LANGAN SUBDIVISION

APPLICATION NUMBER 16 DATE November 20, 2003
APPLICANT Langan Subdivision
REQUEST Subdivision

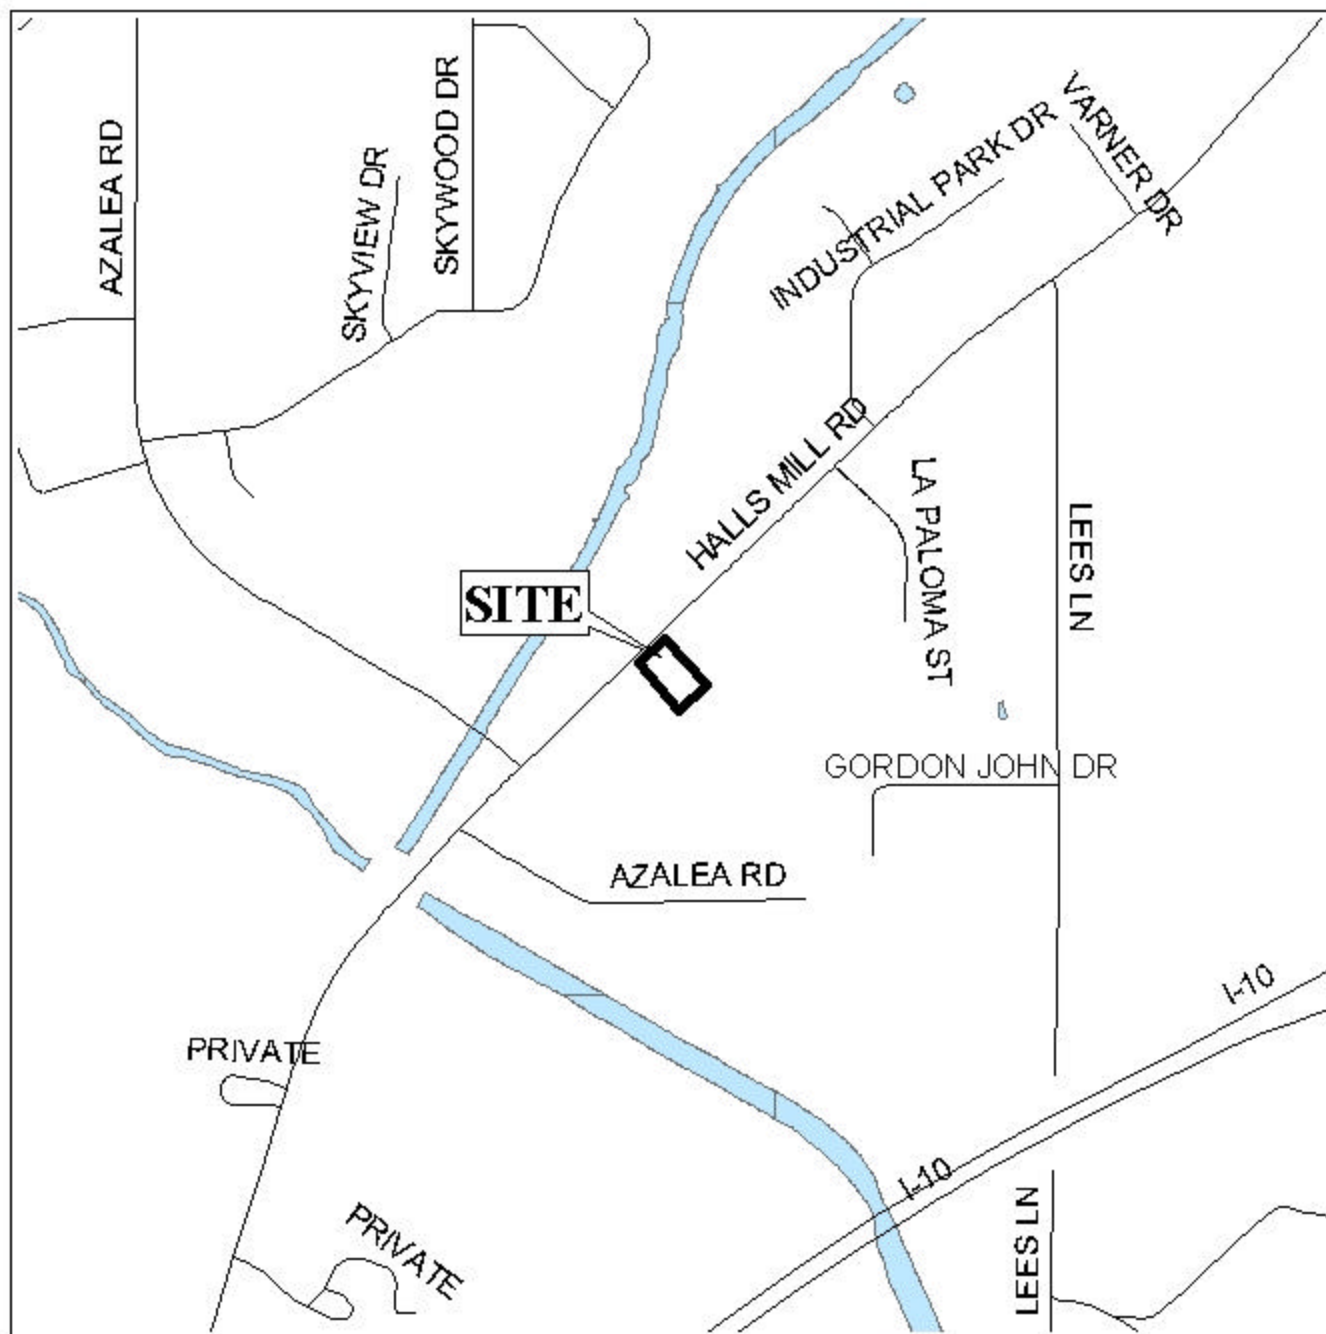
Halls Mill Road is a collector street and as such requires a minimum right-of-way of 70 feet; therefore, the dedication of sufficient right-of-way to provide 35' from the centerline of Halls Mill Road, should be required. Additionally, the placement of a note on the final plat stating that the site is limited to one curb cut to Halls Mill Road, with the size, location and design approved by Traffic Engineering, should be required.

Also, the illustration of the required 25-foot building setback line (from dedication, not from existing property line).

The plat meets the minimum requirements of the Subdivision Regulations and is recommended for Tentative Approval subject to the following conditions: 1) the dedication of sufficient right-of-way to provide 35' from the centerline of Halls Mill Road; 2) the placement of a note on the final plat stating that the site is limited to one curb cut to Halls Mill Road, with the size, location and design approved by Traffic Engineering and 3) the illustration of the required 25-foot building setback line (from dedication, not from existing property line).
